FISH PASSAGE CENTER

MEMORANDUM

RE: Comments on NMFS 2001 Report and Bill Muir's NMFS' Presentations to NWPPC and IT.

Figure 1. NMFS season survival estimates Lower Granite Dam tailrace to McNary Dam tailrace for yearling chinook from 1995 to 2001 plotted with average flows during BiOp flow period in Snake River.

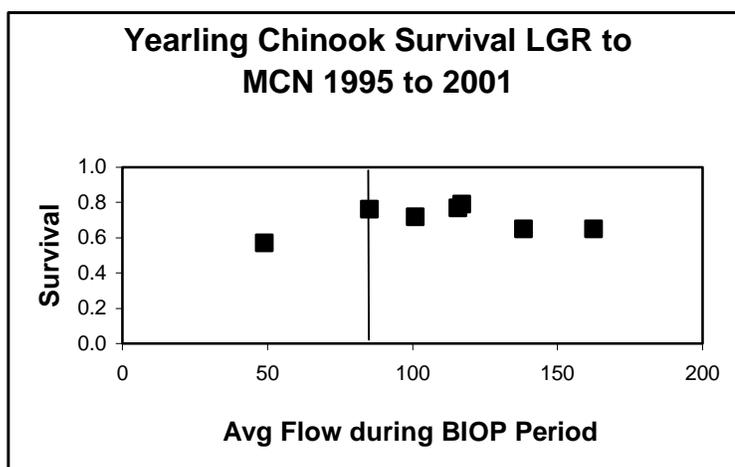
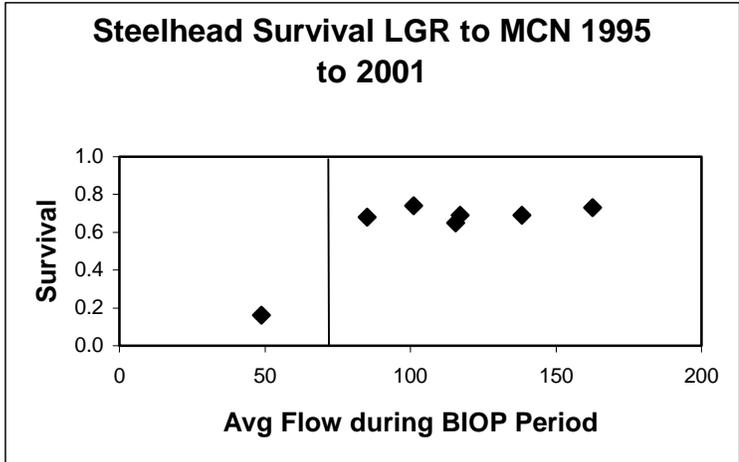
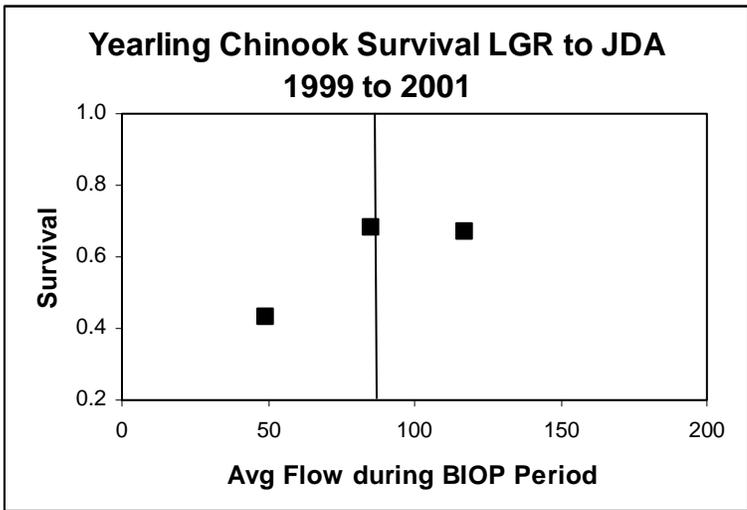
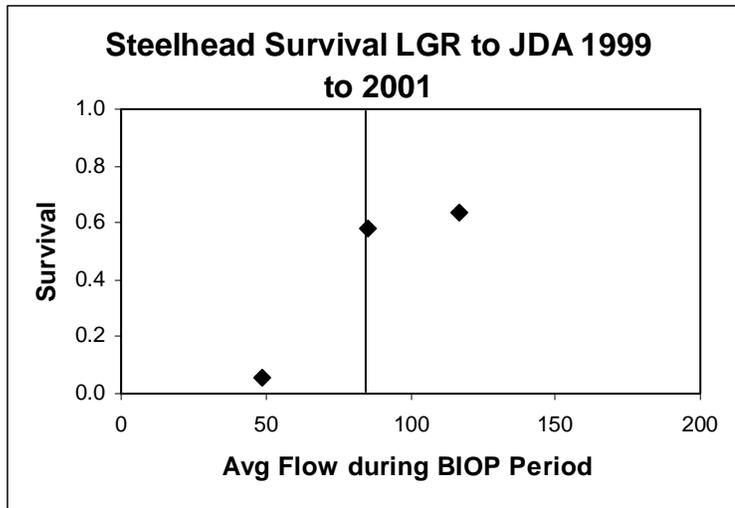
NMFS found no significant relationship between flow and survival when they regressed their flow index versus seasonal per project survival. But their per project survival rate compresses data points between 0.9 and 0.98. This probably makes it very difficult to find any significant relationship from this sort of presentation of the data.

An alternate means of comparing survival among years may include observations for the longest reaches over which survivals have been estimated for all years, compared to seasonal flow conditions. In this analysis the flow index was average discharge during the period that the BiOp sets spring targets for flow and spill at the Snake Projects. Flow is compared to seasonal survivals for the years 1995 to 2001 for the reach LGR to MCN, and for the years 1999 to 2001 for the reach from LGR to JDA. (These are the only years for which PIT-tag survival estimates were calculated for these entire reaches.) As can be seen in figure 1, the LGR to MCN survivals of yearling chinook remain above 65% for the years 1995 to 2000, when flows are at or above the BiOp flow target of 85 kcfs during the BiOp spill season, but fall to 57% in 2001. For steelhead, the LGR to MCN reach survivals also remain above 65% when flow targets were met and plummet to 16% in 2001, when target flows were well below the BiOp target spill levels (Figure 2). For the years 1999 to 2001 there was sufficient data available for the longer reach LGR to JDA. Plots comparing those years (Figures 3 and 4) do show a similar trend to the shorter reach; survival in 2001 was considerably lower than 1999 and 2000.

Figure 5a. Yearling Chinook Survivals MCN to JDA tailwater, Spill proportion at JDA, and Average Total Discharge at John Day during pre-spill, spill and post-spill blocks at JDA 2001.

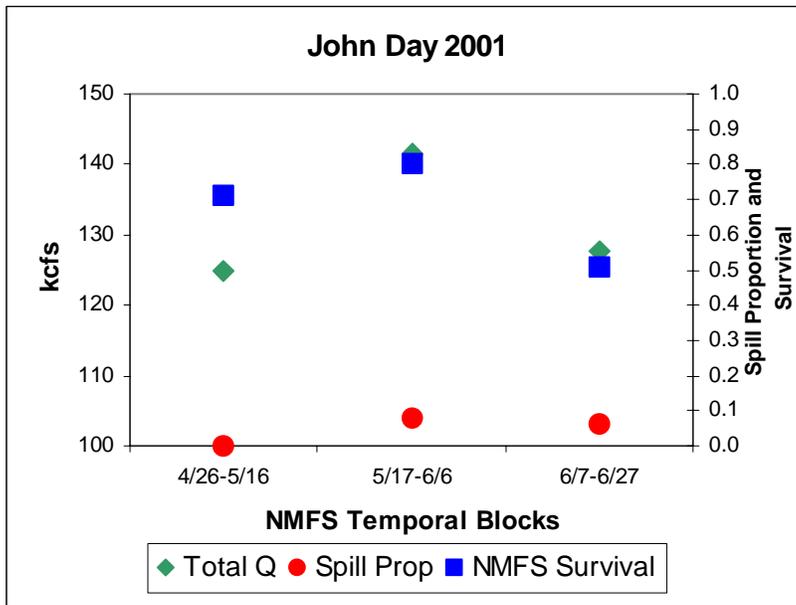
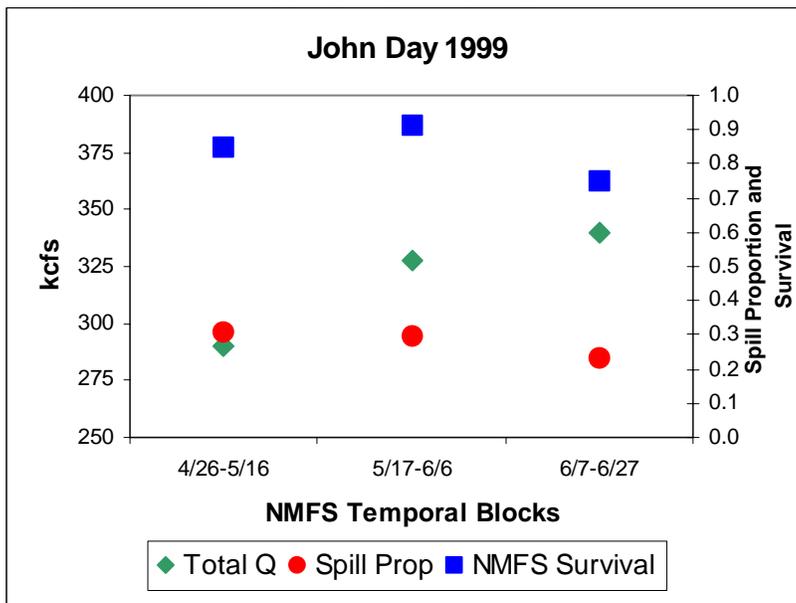
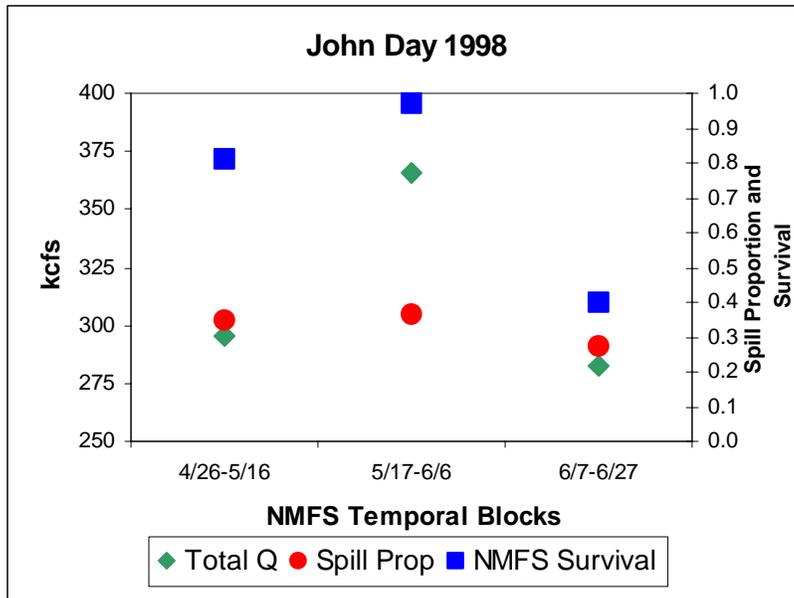
A temporal effect cannot be demonstrated unless flow and spill remain relatively stable over that period each season. Flows and spill did not remain constant during these time periods. In fact, using the time periods NMFS blocked for their presentation to NWPPC we found the highest survivals occurred during the periods of the highest flows and spill proportions in 1998 and 2001 (Figures 5 a,b,c). In 1999, the differences in survival were the smallest among the three periods. In that year spill was manipulated in blocks of low and high daily spill during early May and was more consistent during the second time period (May 18 to June 6) and decreasing in the

third block. Also, flows increased over the three blocks while proportion spilled decreased. So that some positive effects of high flows and higher spill proportion might counterbalance each other, resulting in more moderate differences in survivals throughout the season. The historical data presented by NMFS could be considered an indication that temporal patterns of survival might be attributed in part to an increase in flow and spill proportions through the passage season. Neither the NMFS presentation nor their annual report recognized this possibility. These findings support the assertion that high flows and spill improve survival.
